CALLEGUAS MUNICIPAL WATER DISTRICT
Thousand Oaks, California

PROJECT NO. 450

FOR THE CONSTRUCTION OF THE
LVMWD-CMWD INTERCONNECTION

ADDENDUM NO. 2

MATCH LINE - DWG NO. C-30

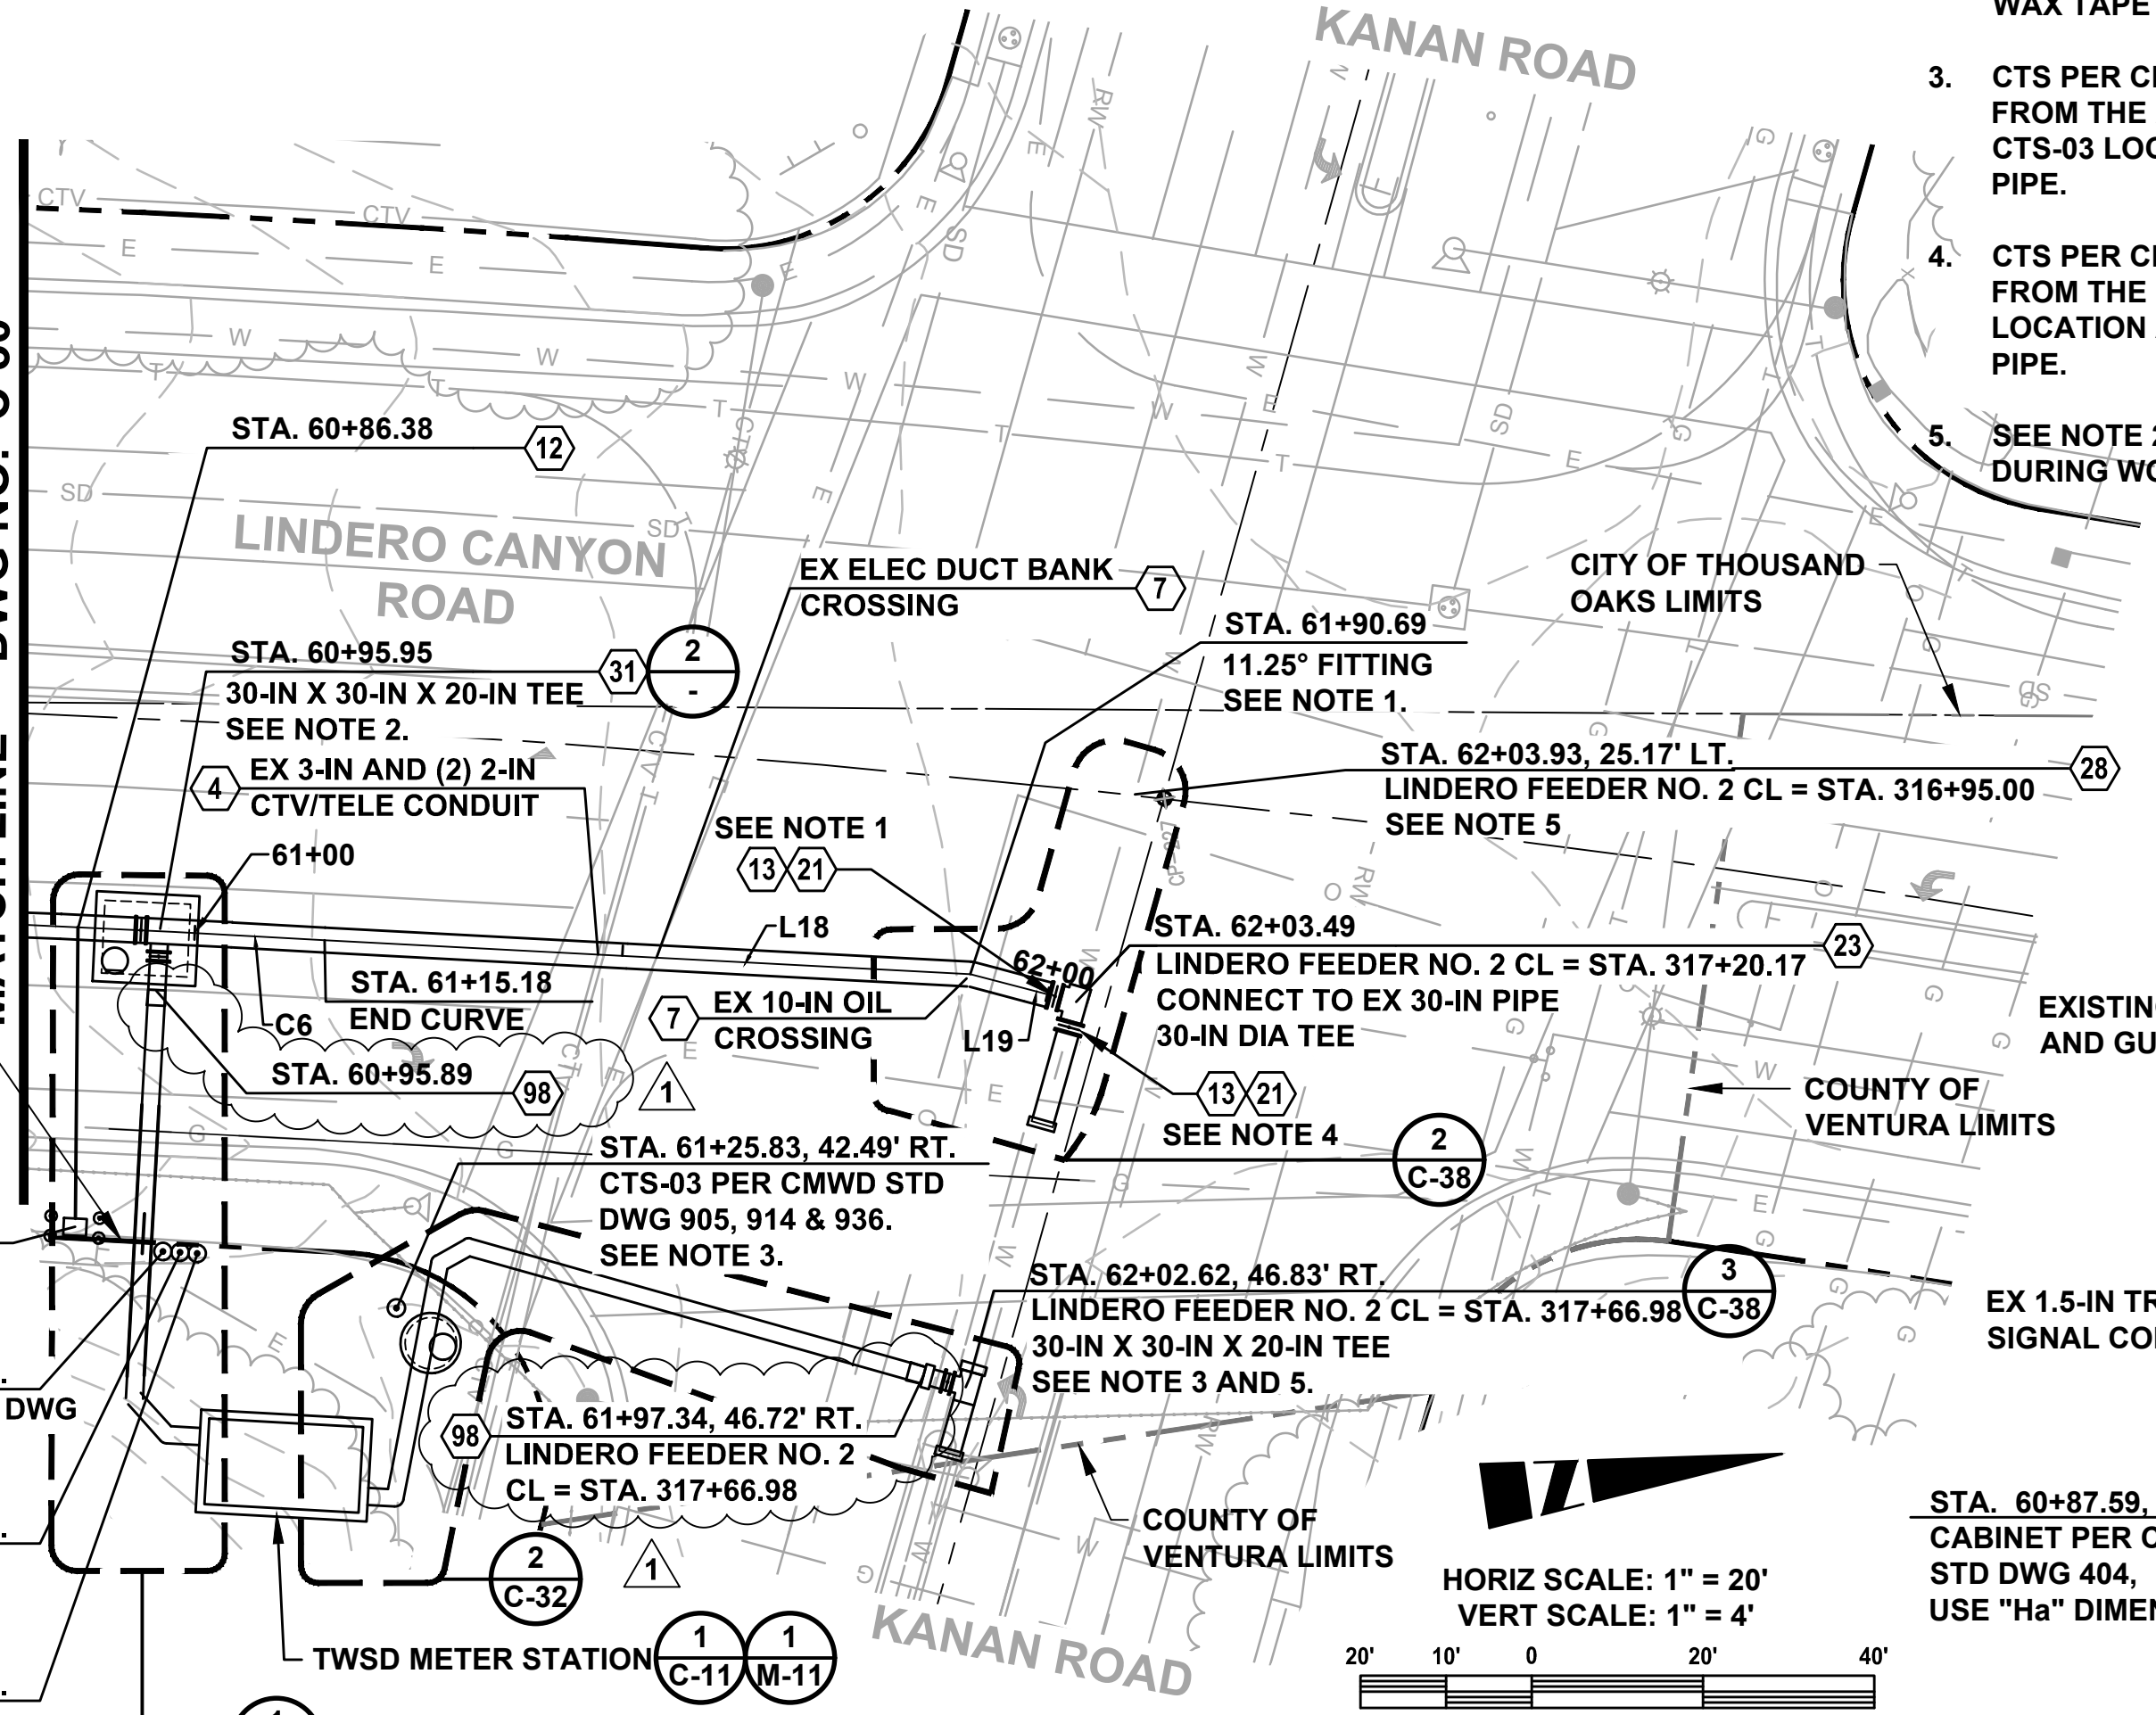
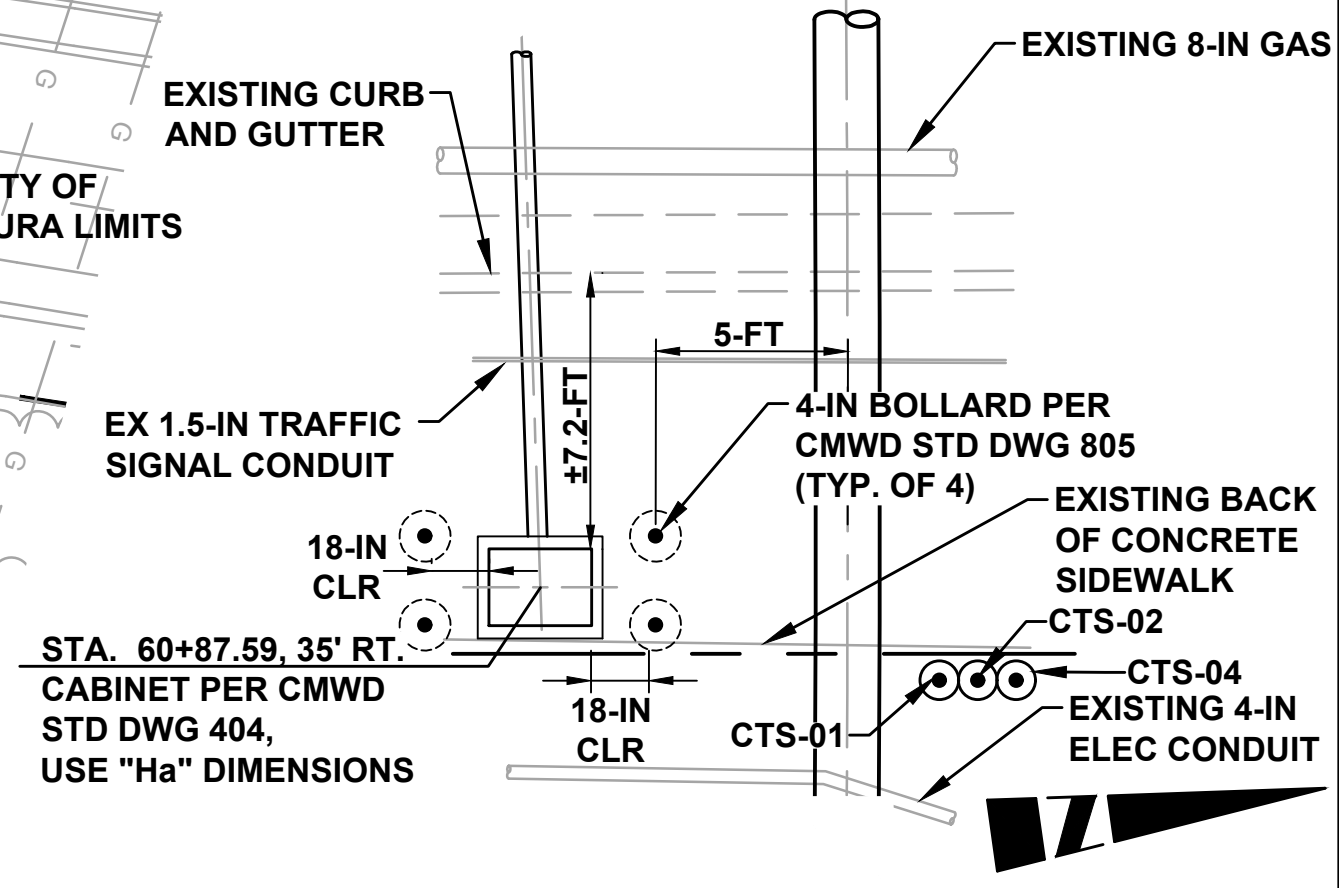
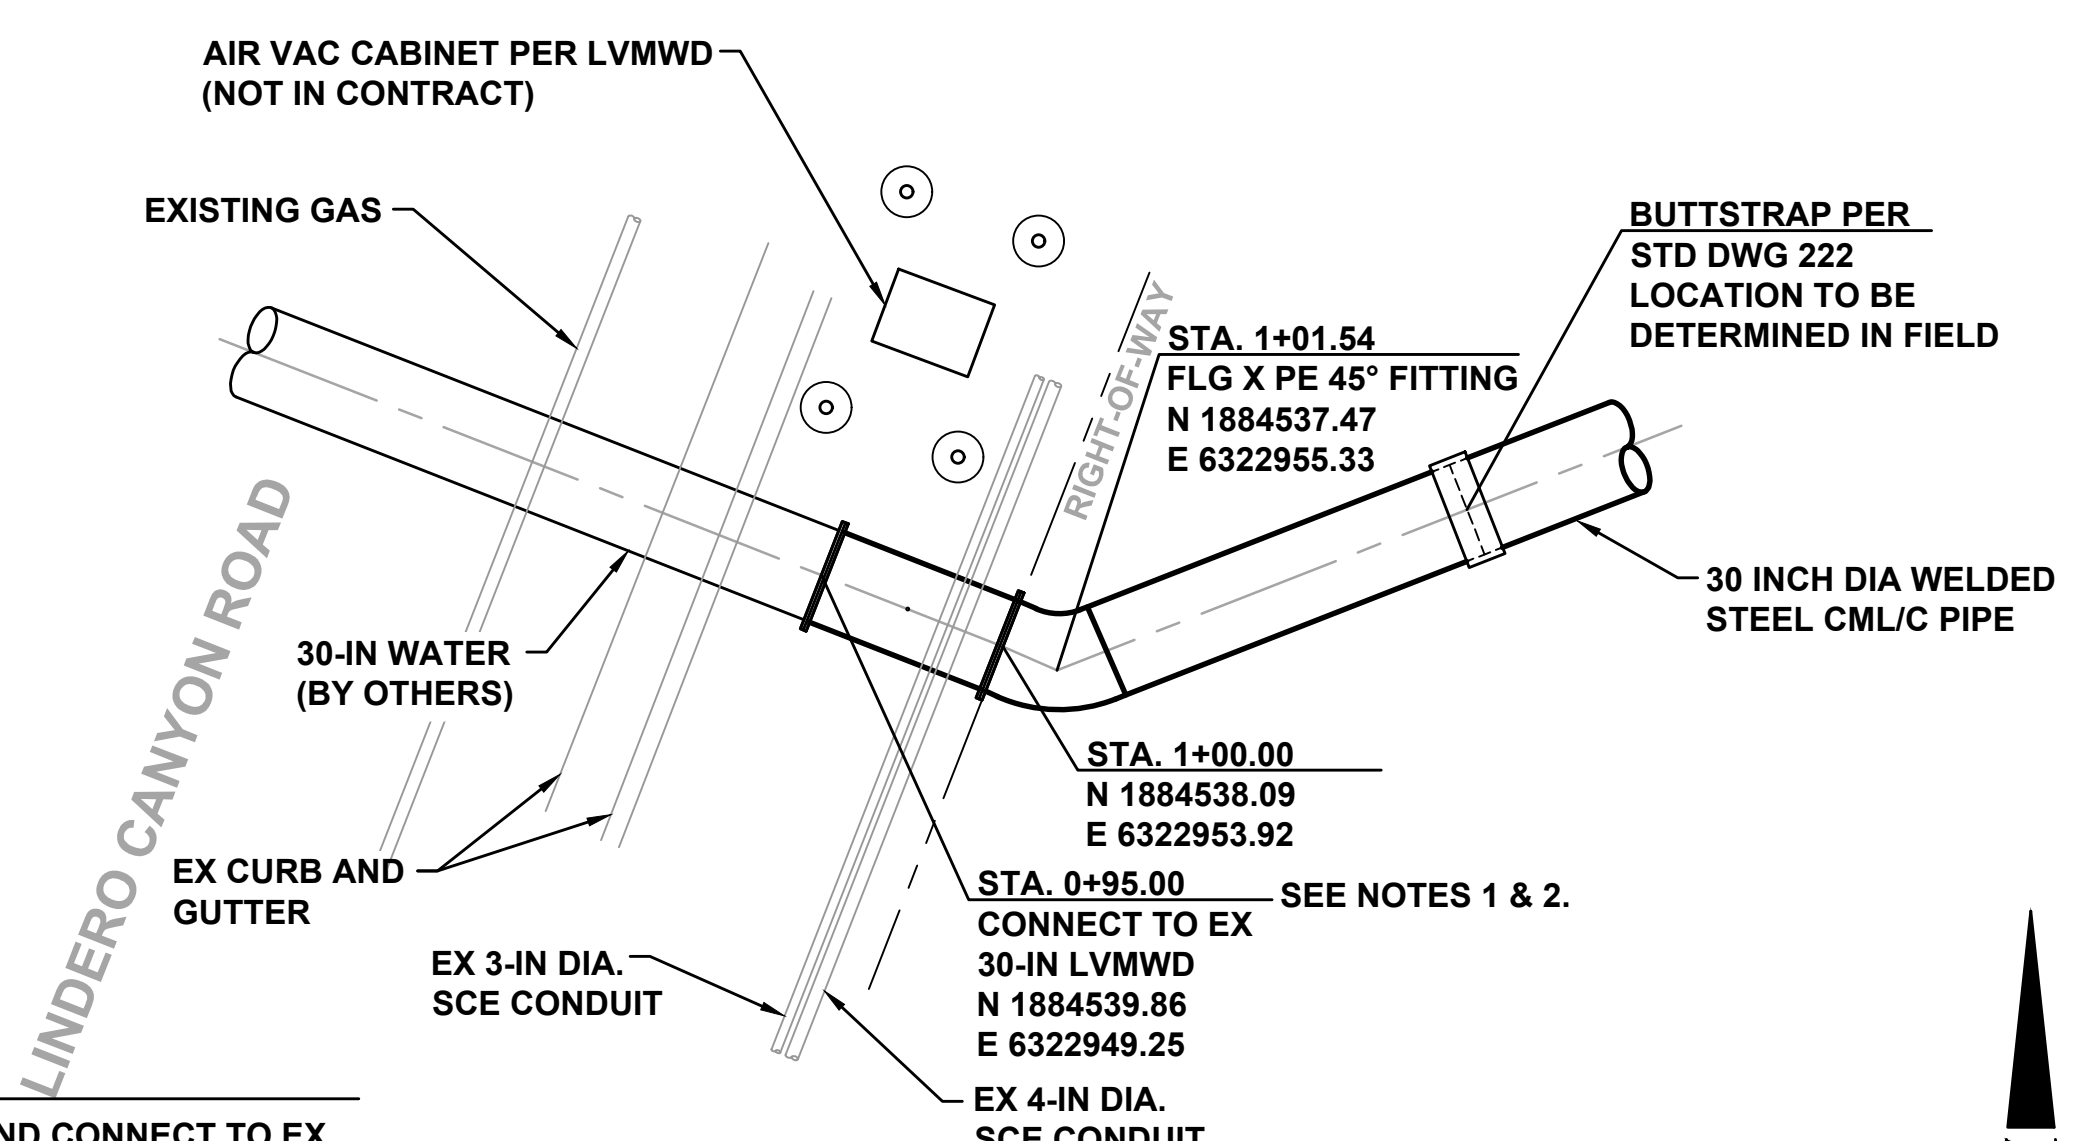
“NO JOINTS IN THE PIPE SHALL BE PLACED WITHIN 10 FEET OF THE SANITARY SEWER UNDERCROSSING LOCATED AT APPROXIMATELY STA 47+06.”
- Item AD2-53 REPLACE Drawing C-31 with the attached Exhibit H3, containing replacement Drawing C-31.
